## REMARKS

PROPOSED AMENDMENT TO THE DRAWINGS

FIGURE 1A

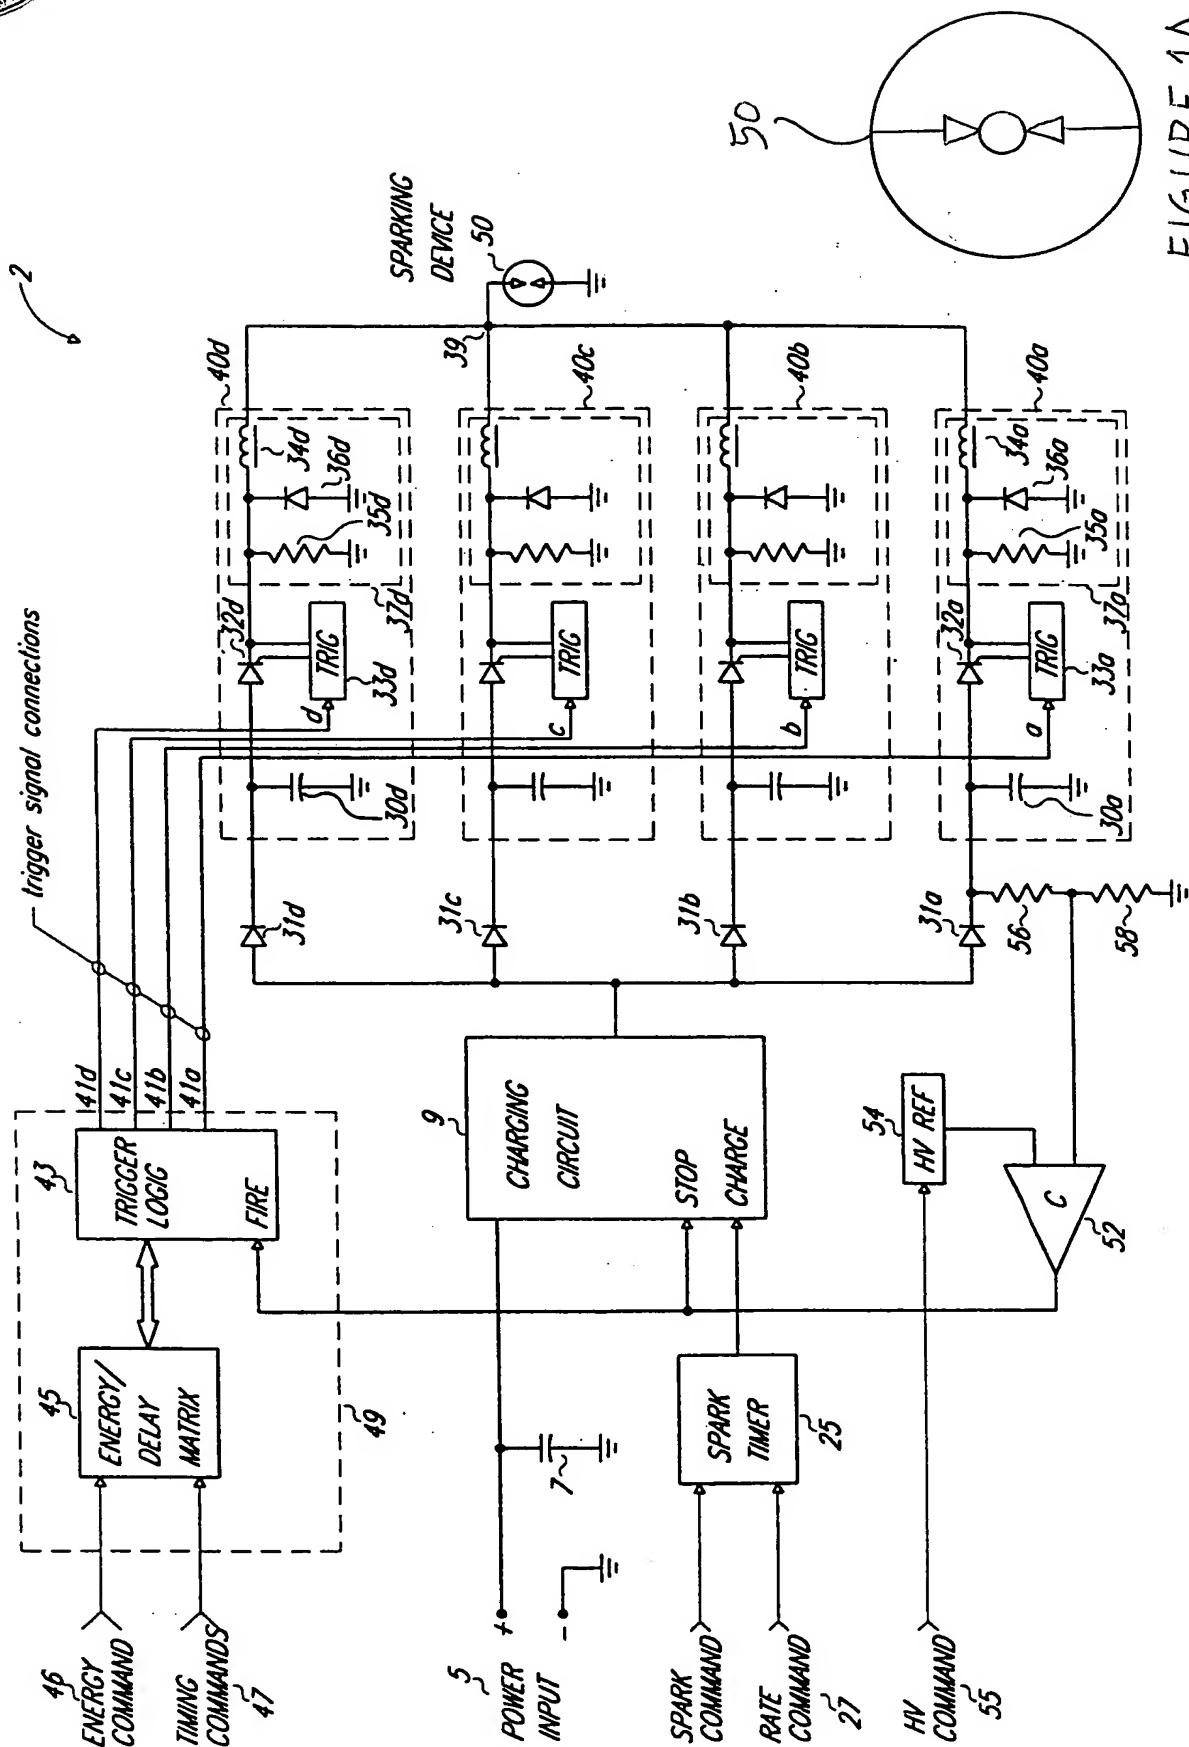
This amendment includes a proposed amendment to the drawings to illustrate the plume shape of a spark as described in the specification at various pages, including for example page 29, starting at line 6 to page 30 at line 4. The drawings were objected to for not illustrating the plume shape as recited in claim 90. Proposed Fig. 1A is a highly schematic representation of the plume shape of a spark event. Although the shape is illustrated as a simple circle, those skilled in the art of ignition systems will appreciate that the circle is not an actual shape.

In the Office action, the drawings are objected to under § 37 C.F.R. 1.83(a) for not showing every feature of the invention specified in the claims. The Office action specifically identifies language in claims 74, 90, 97 and 98. The Office action requires corrected drawings filed in accordance with Rule 121(d). Attached hereto is a proposed amendment to the drawings adding Figures 1A and 3A to sheets 1 and 3, respectively, of the original drawings. Pursuant to Rule 121 (d), replacements for sheets 1 and 3 are also attached.

FIGURE 3

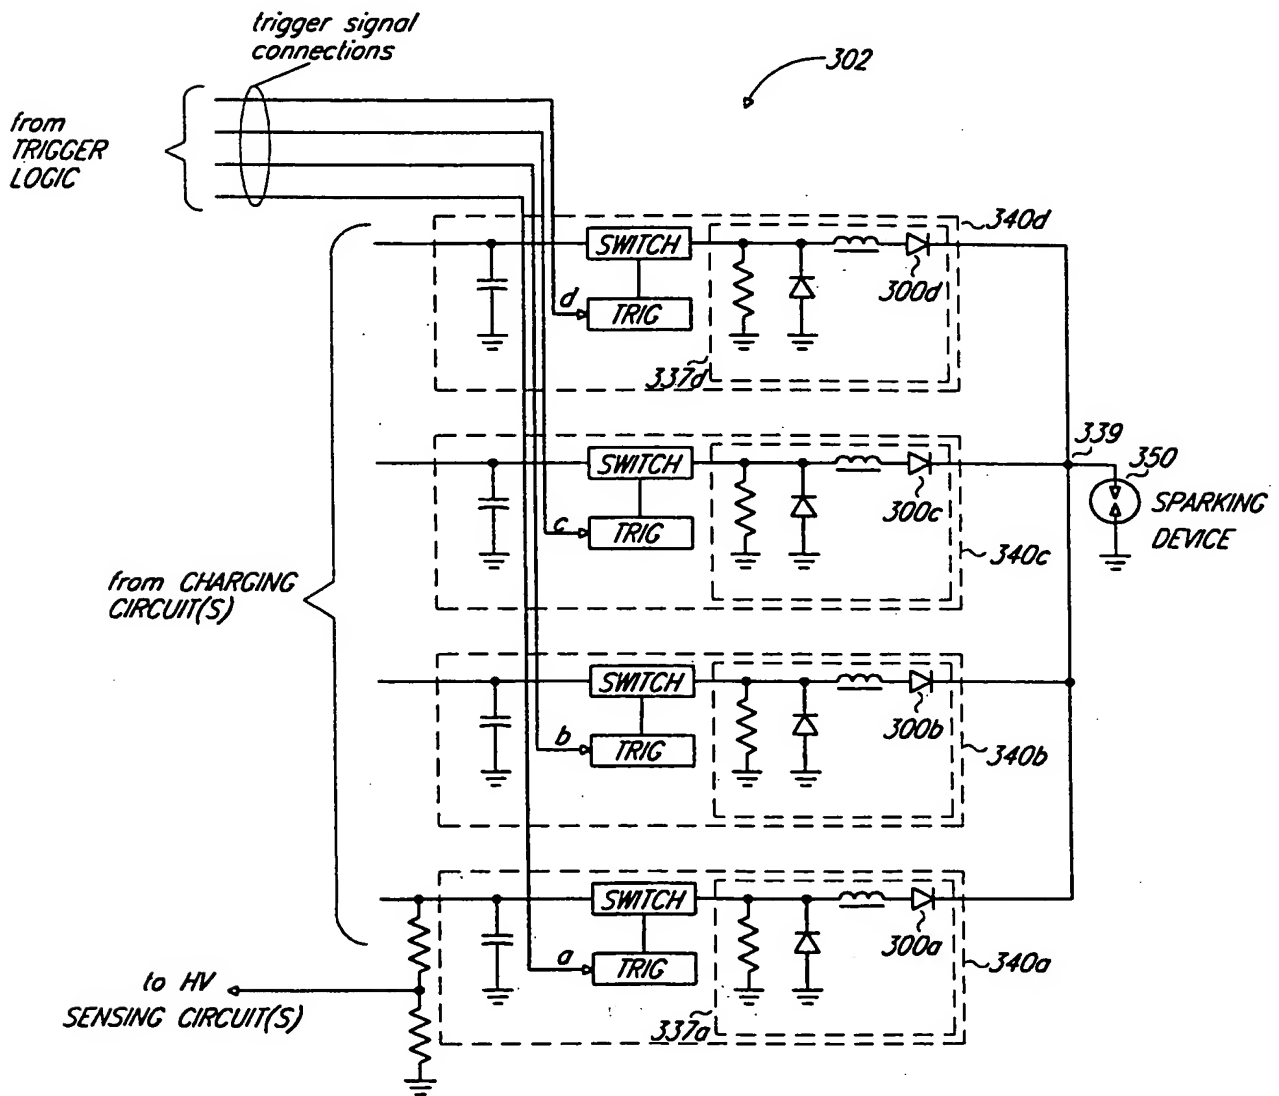
The drawings were also objected to for not illustrating the discharging of the several energy devices into a single spark generating device "at substantially the same time," citing claims 74, 97 and 98. Original Figures 1 and 3 illustrate four output circuits 40a-40d and 340a - 340d, respectively, connected to a single sparking device 50 and 350, respectively. Proposed Fig. 3a is a timing diagram illustrating discharge pulses from each of the output circuits 340a - 340d of Fig. 3 such that the pulses are delivered to the sparking device 350 "at substantially the same time." The timing overlap of the energy pulses to the devices 50 and 350 in Figs. 1 and 3, respectively, is described in detail in the original specification at, for example, page 20, lines 5-11 and page 29, lines 18-23 and in at least original claim 70.
